PERRY NUCLEAR POWER PLANT PROJECT ORGANIZATION
CEI NUCLEAR ENGINEERING DEPARTMENT
AND KAISER ENGINEERS, INC.

July 24, 1981

Re: MEB SER

Attached is our preliminary response to open items identified in the Draft MEB SER for sections 3.2, 3.6, 3.7, and 3.9. These responses will be used as a starting point for our August 4 meeting.

Figure 3.6-75

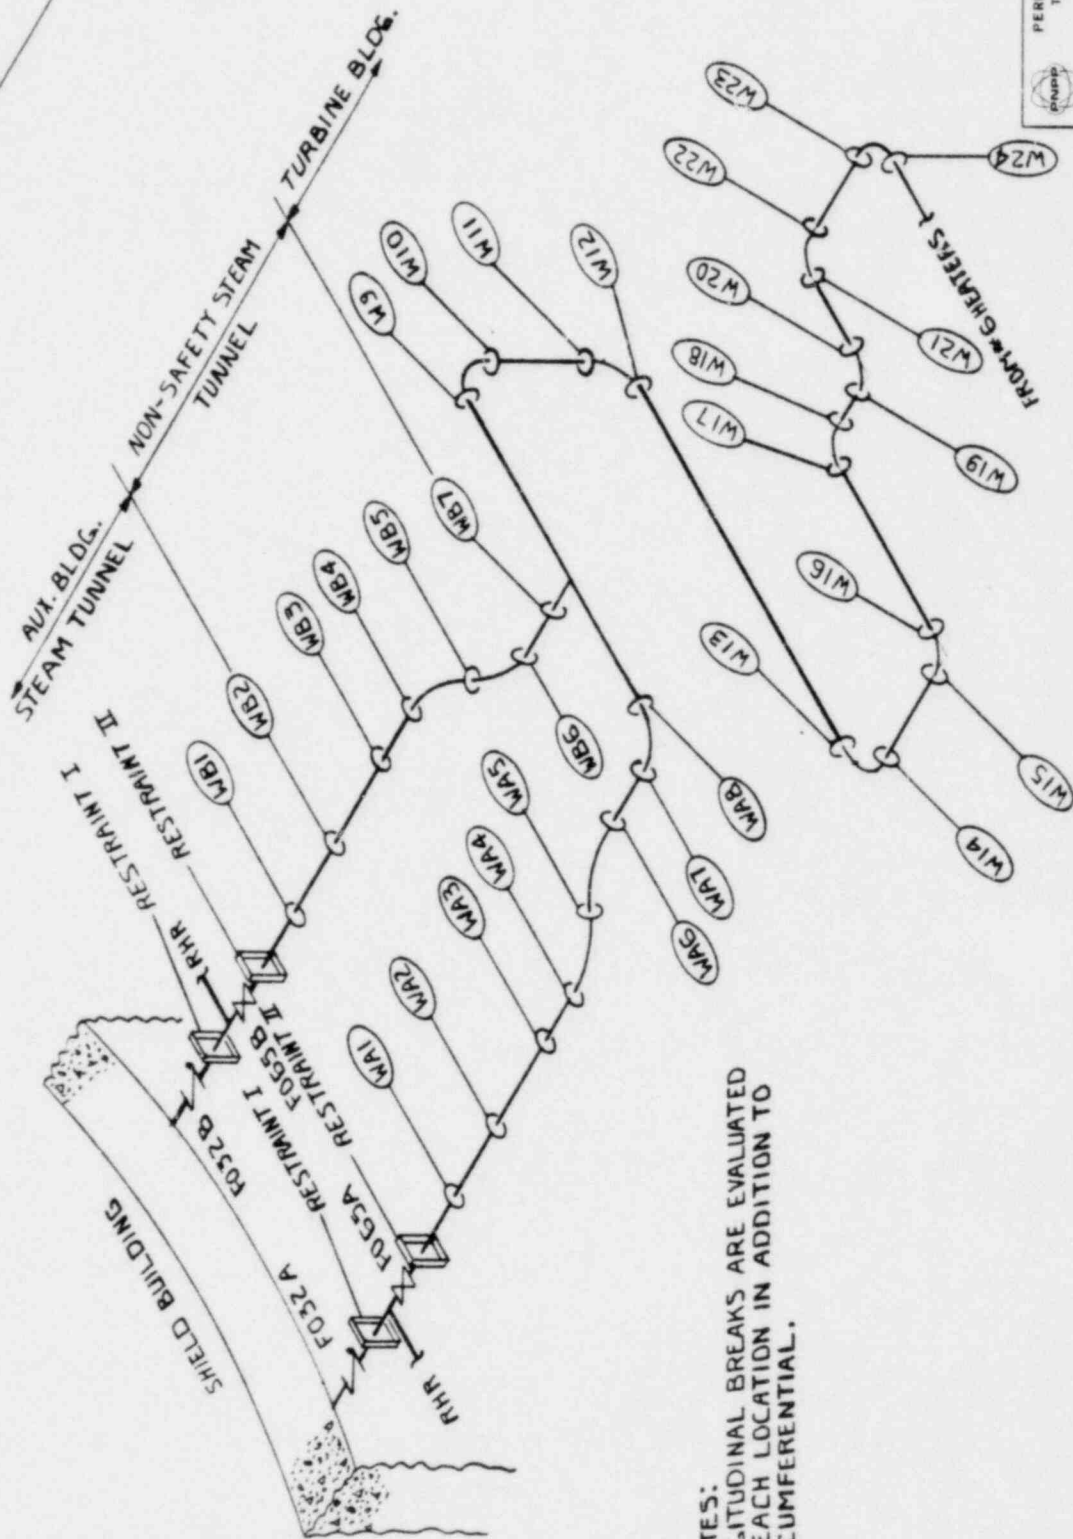
DSER 3.6-30 Indicate the location of valves in this line.
(3.6.2,
Figure 3.6-75)

Figure 3.6-75 has been revised to show valve locations.
